## SUPPLEMENTARY ASSESSMENT REPORT TO PANEL – Prepared by Purdon Planning

### SOUTHERN REGIONAL PLANNING PANEL

<b>PANEL REFERENCE &amp; DA NUMBER</b>	Panel Reference Number PPSSTH-224 DA number DA.2023.0044
<b>PROPOSAL</b>	Construction of shop-top housing, comprising: <ul style="list-style-type: none"> <li>▪ Two 10 storey buildings,</li> <li>▪ Sixteen commercial premises at ground floor level,</li> <li>▪ 178 residential units above ground floor level (including 15% of 'affordable housing' (i.e. 27 apartments) managed by a community housing provider),</li> <li>▪ Two levels of basement parking,</li> <li>▪ Demolition of 3 existing single storey dwellings and 3 community/commercial buildings,</li> <li>▪ Removal of 7 trees (6 on-site, 1 off-site),</li> <li>▪ Retention of two heritage buildings (Old Fire Station, Dutton's Cottage),</li> <li>▪ Consolidation of Lots 31 DP771673, Lot 2 DP748338, Lot 18 DP548244 and Part Lot 2 DP 1179998</li> </ul>
<b>ADDRESS</b>	6-12 Rutledge St and 257 Crawford St Queanbeyan, being: <ul style="list-style-type: none"> <li>▪ Lot 31 DP771673,</li> <li>▪ Lot 2 DP748338,</li> <li>▪ Lot 18 DP548244,</li> <li>▪ Part Lot 2 DP 1179998</li> </ul>

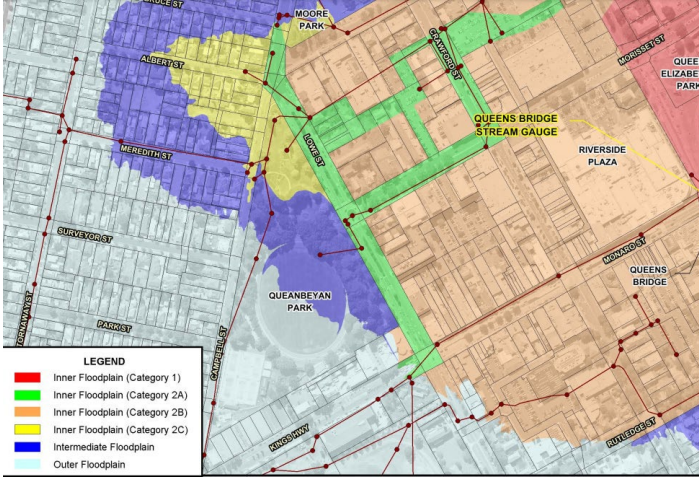
Item	Matters for Consideration	Satisfied (Y/N)
	<p>Clause 4.3(g) of the QPRLEP 2022 states</p> <p><i>(g) to provide appropriate height transitions between buildings, particularly at zone boundaries.</i></p> <p>The applicant's submission (dated 28 August 2024) did not respond to the clause but stated "the QPRLEP 2022 does not include development controls regarding transitional height requirement". This is clarified in the applicants latest submission (dated 3 October 2024) that the appropriate height transitions to the residential areas to the south have been appropriately addressed for the following reasons</p> <ul style="list-style-type: none"> <li>• Level 1, the building steps back from the colonnade edge, with a consistent building line between levels 1-7. The finished floor level of Level 7 is set at approximately 25.75m, which is 750mm exceedance of the maximum building height.</li> <li>• Level 8, the building steps back further to achieve height transitions to the residential areas to the south</li> </ul> <p>In addition, it is considered that the locational context of the subject site supports a transitional height outcome by physically and visually separating the proposed development from the southern residential areas (a road reserve width of approximately 30m). Mature trees on both sides of Rutledge Street also provides for prudent massing and transitional height relief.</p> <p>The application of the brick colonnade and Level 1 balcony, along with street tree plantings also contribute to the transition between zones at street level, with the eye line of pedestrians and commuters interacting primarily with the base of the building.</p> <p>On the above basis, the assessment report concludes the proposed buildings have achieved appropriate height transitions to the residential areas to the south pertaining to clause 4.3(g) of the QPRLEP 2022.</p> <p><b>Proposed outcomes and management of the Heritage well below floor level</b></p> <p>The well will be reconstructed in its original location and covered with a trafficable glass floor for viewing (Internally, a black mirror will be used to simulate a well shaft). A historical plaque will also be provided with a narrative detailing the history of the well. The information is shown in Architectural Plan 79 Water Well-Proposed Detail (Rev F) (Kasperek Architects 11 July 2024).</p> <p>On 24 September 2024, Purdon requested further clarification on the management on the heritage well. The applicant confirmed that the existing bricks will be used to reconstruct the well where practicable. This is considered consistent with one of the Panel's suggested measures for the well</p> <ul style="list-style-type: none"> <li>• <i>installation of a transparent walkway/floor to view the well insitu;</i></li> </ul>

Item	Matters for Consideration	Satisfied (Y/N)
	On the above basis, the assessment report concludes that the latest submission (dated 3 October 2024) has demonstrated its treatment of the proposed well including the below floor level.
